PRODUCT CHANGE NOTICE

PCN#23-081**NOTIFICATION DATE: November 30, 2023****MODEL(S) AFFECTED:****RUDAT-13G-60****EXTENT OF CHANGE:**

New – QF3370

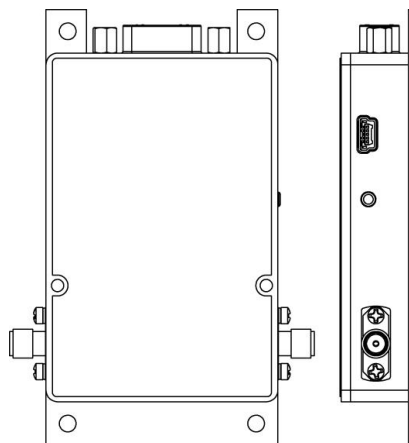
- Change in FUNCTION (Performance): Bracket assembled at factory, no need for customer to assemble bracket manually.
- Change in FIT (Appearance) : Added cutout to bracket below D-Sub connector to make connecting unit easier.
- Change FORM (Dimension) as follows:
 - Option without bracket canceled.
 - Height with bracket changed from 0.7" to 0.68"
- Case style drawings:
